Response to SBVAS-1 and SBVAS-2

Re: **Revised and Recirculated Environmental Impact Report for the
Moon Camp Residential Subdivision**

Response to SM&W-1

RE: Draft Re-circulated EIR for Moon Camp Development Project/RCK Properties
(SCH # 2002021105)

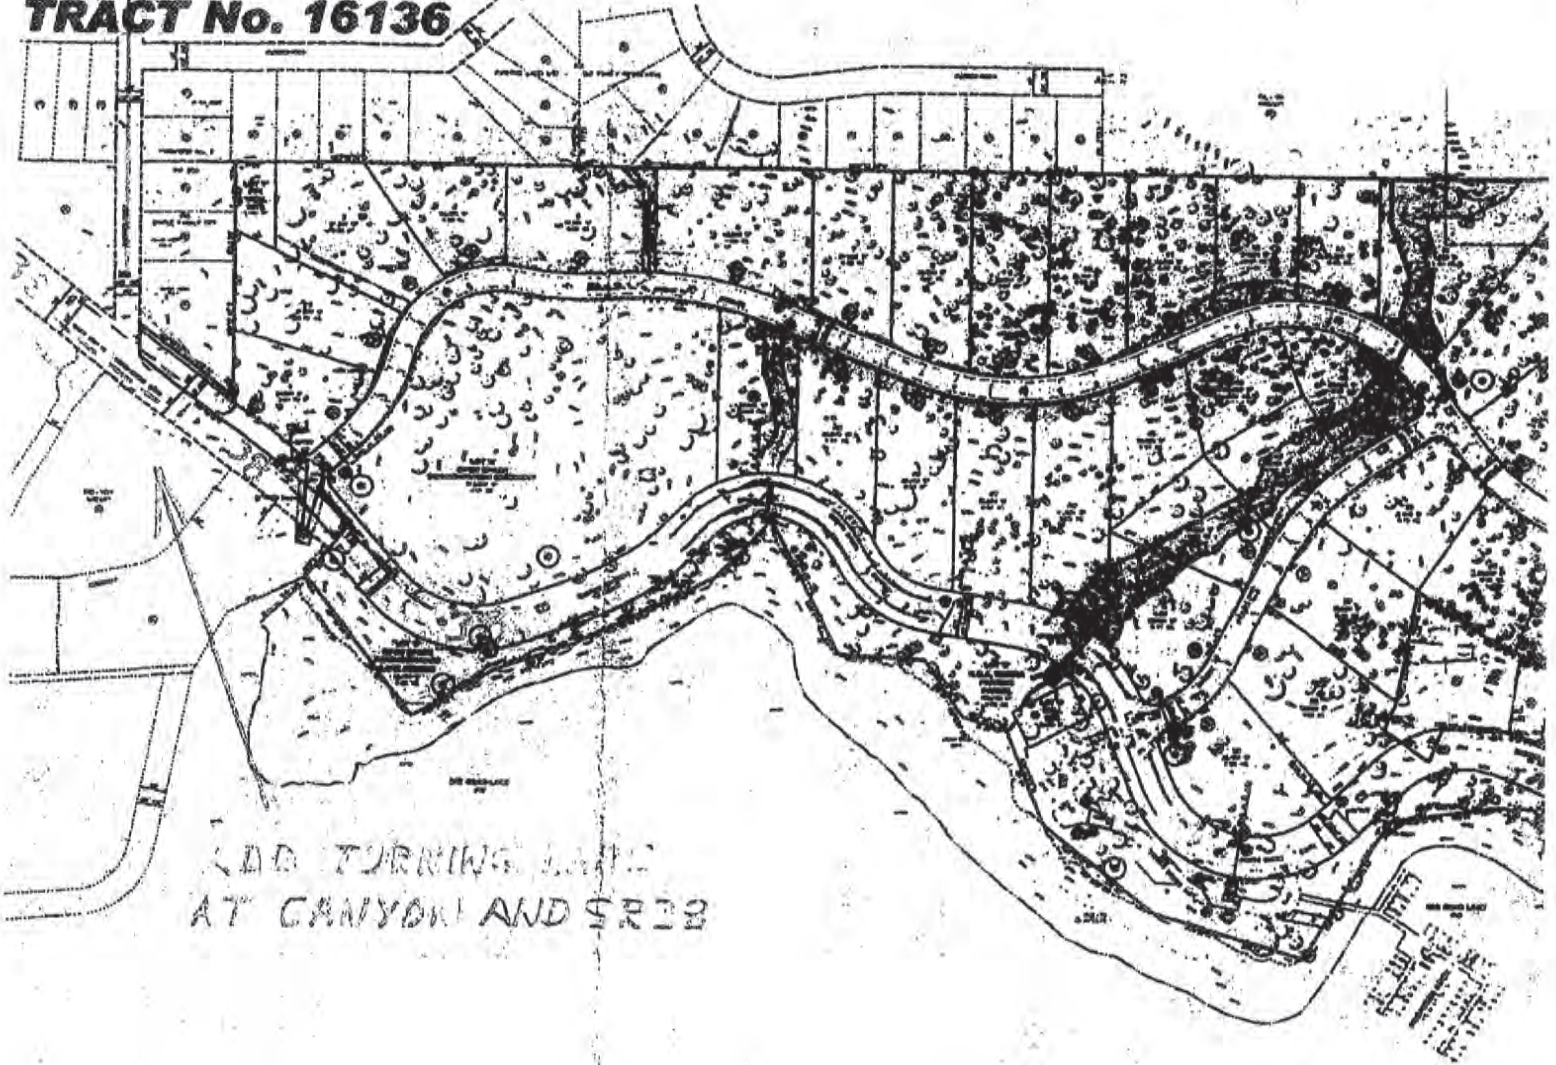
THIS INTERSECTION ALSO SERVES AS A SCHOOL BUS STOP FOR THE ELEMENTARY GRADES.

CANYON IS ONLY 300 FEET (EST.) WEST OF THE NEW PROJECT DRIVEWAY #1.

I SUGGEST AN AMPLE WIDENING OF SR 38 EAST/WEST WHEREBY A DUAL DIRECTION LANE BE PLACED IN THE CENTER BETWEEN THE EAST BOUND AND SOUTH BOUND LANES TO SAFELY ENABLE TRAFFIC TO GET ON TO AND OFF OF CANYON.

Figure 1. Concentrations of SO₂ and PM as well as excess deaths during 1952 London smog episode. The red arrow indicates the estimated PM concentrations for 50 homes in Moon Camp using wood-burning fireplaces.

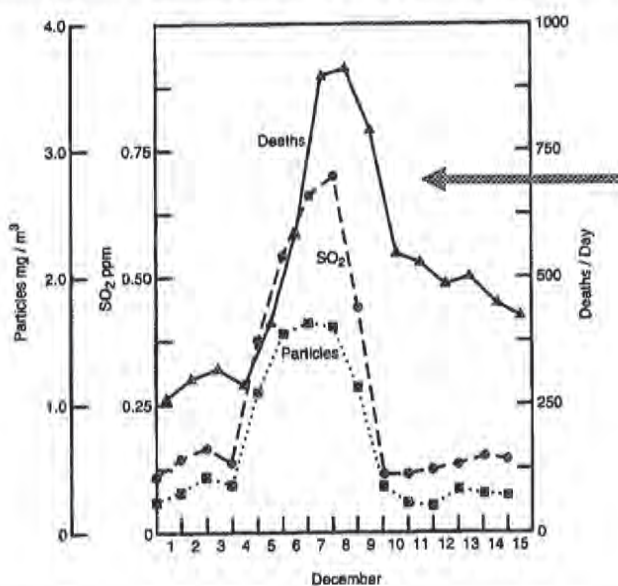
As another basis for comparison of the potential local effects of PM emissions from the 50 homes, Figure 1 shows data from the "killer smog" that occurred in London in 1952. The concentrations of sulfur dioxide (SO₂) and particles (same as PM) are plotted during this episode, along with the excess deaths that it caused, which are attributed to PM. The red arrow indicates the estimated PM concentrations for 50 homes in Moon Camp using wood-burning fireplaces. Clearly, the Moon Camp situation could present a situation similar to the London episode that caused a dramatic increase in mortality. Note,

however, that the AQS that are set to protect public health are much lower than this, again indicating an expectation of severe health impacts at the project location and downwind.
